**STATE OF TENNESSEE
DEPARTMENT OF TRANSPORTATION**

INSTRUCTIONAL BULLETIN NO. 16-09

Regarding Revised, New and Voided Standard Drawings

Effective December 2, 2016 letting (September 27, 2016 Turn-in), the following Standard Drawings have either been revised, are new, or have been voided. Also, Section V of the Roadway Design Guidelines will be revised to incorporate these changes.

FLARED
 SINGLE SLOPE
 CONCRETE MEDIAN
 BARRIER WALL
 (VERTICAL BACK)

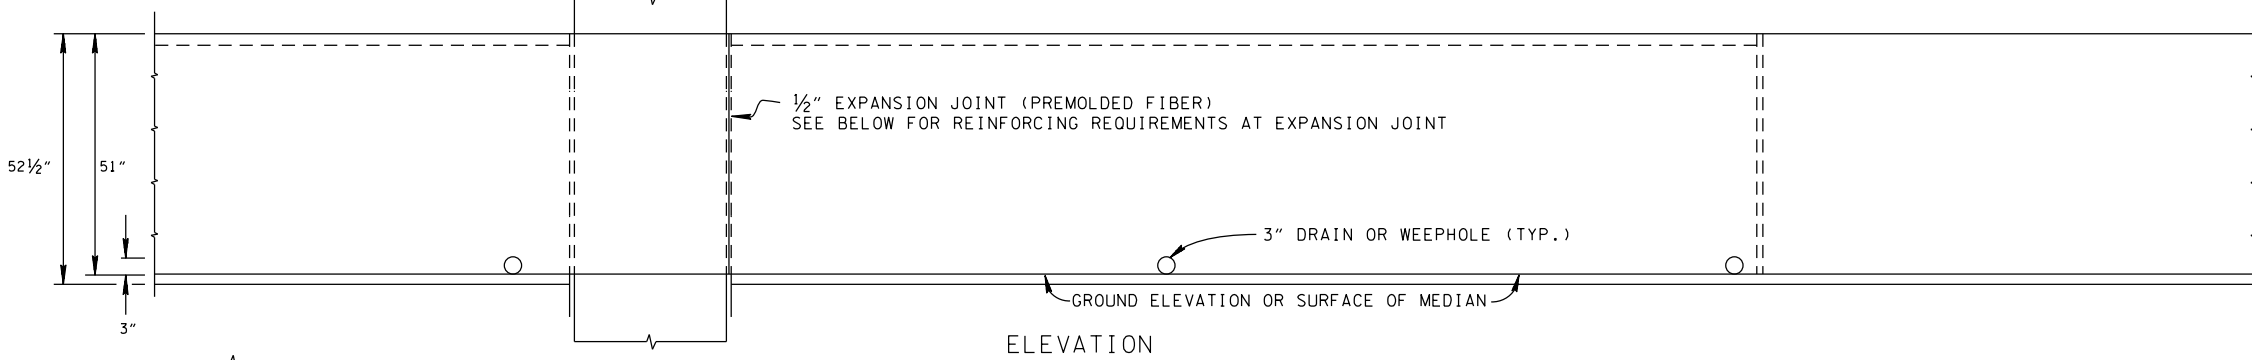
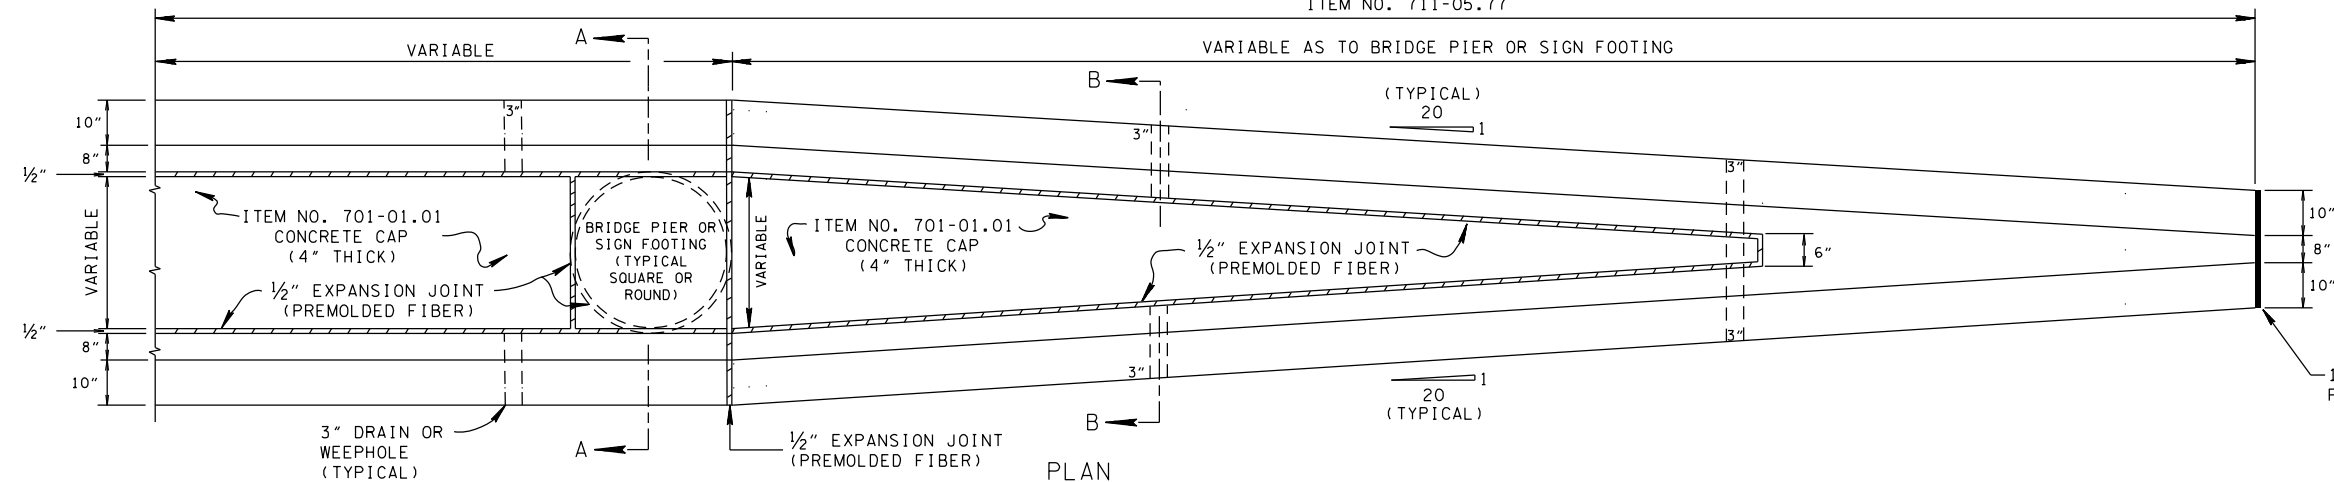
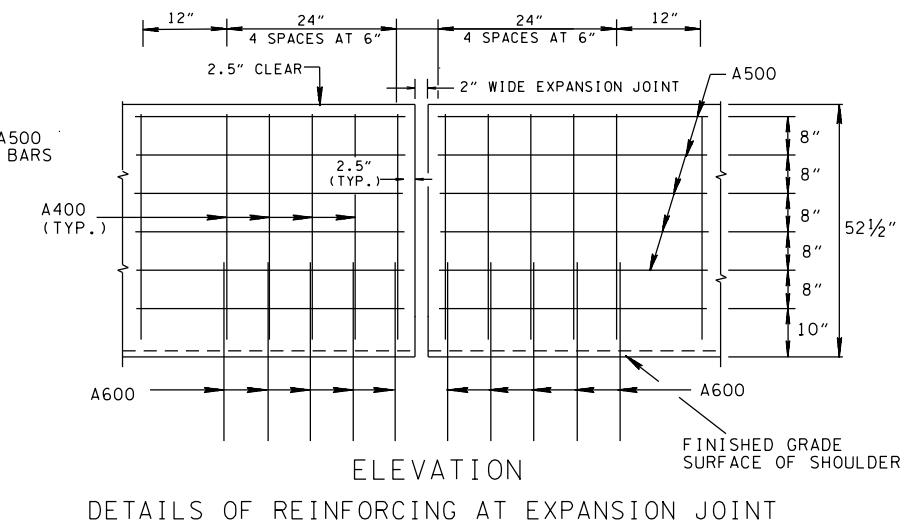
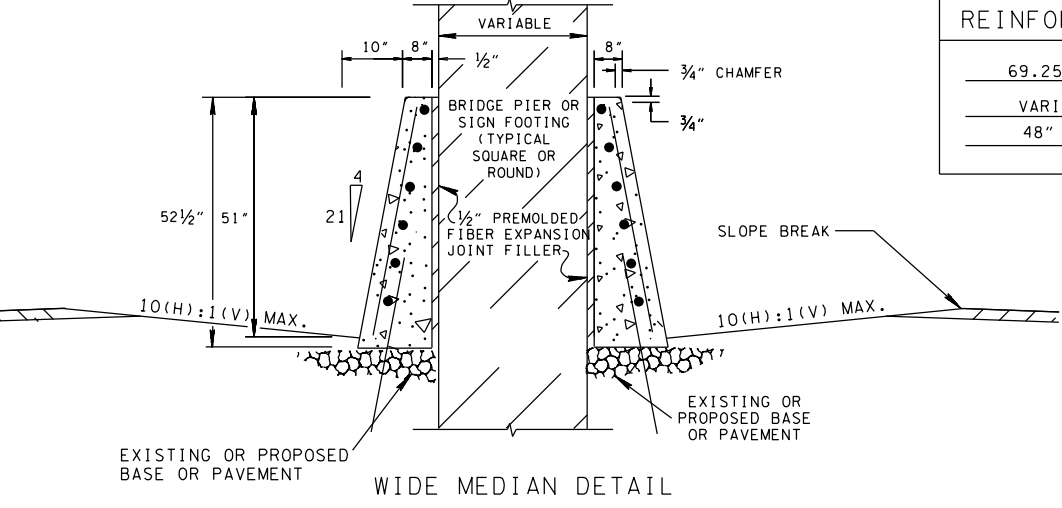
REV. 7-30-10: REVISED REINFORCING STEEL DETAILS AND GENERAL NOTES.
 REV. 4-12-16: UPDATE REFERENCES TO STANDARD DRAWINGS, ADDED REINFORCEMENT DETAILS.

STANDARD PRECAST
 48" CIRCULAR NO. 28
 CATCH BASIN
 (FOR USE WITH 4"
 SLOPING CURB)

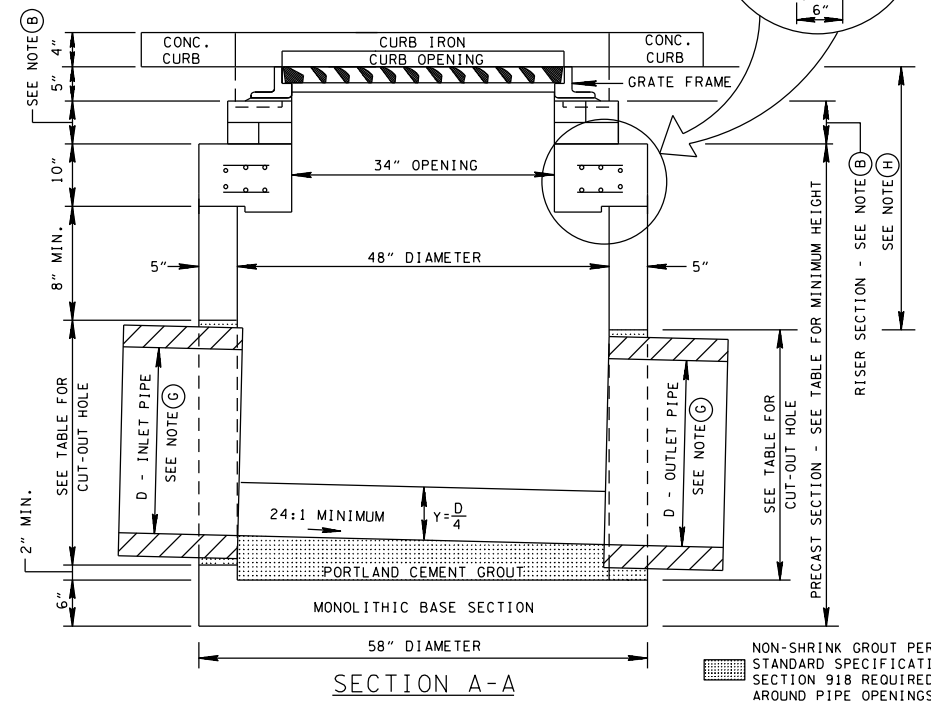
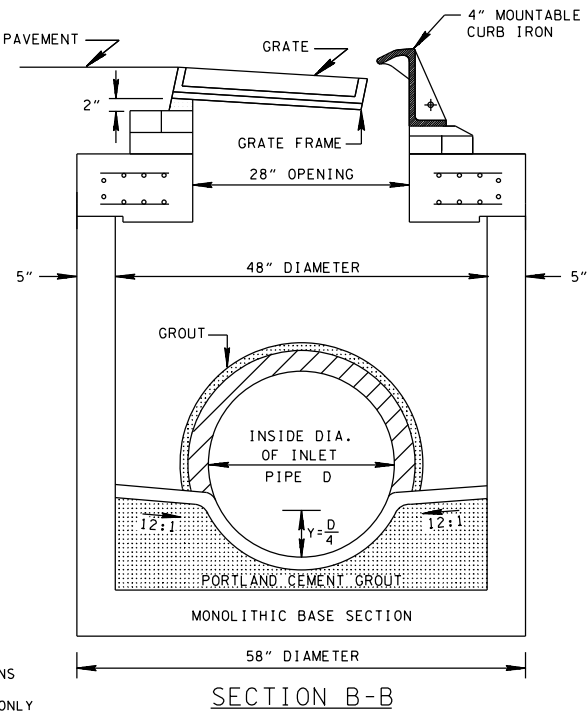
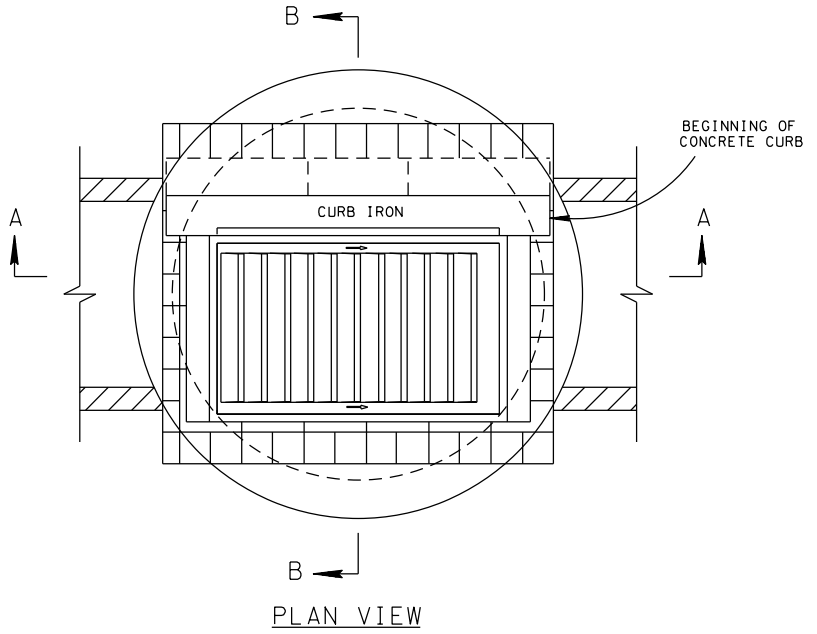
- REV. 9-24-12: MODIFIED TOP SLAB AND MINIMUM DEPTH.
- REV. 3-11-14: ELIMINATED STIRRUPS.
- REV. 4-12-16: CORRECTED GENERAL NOTE (D).
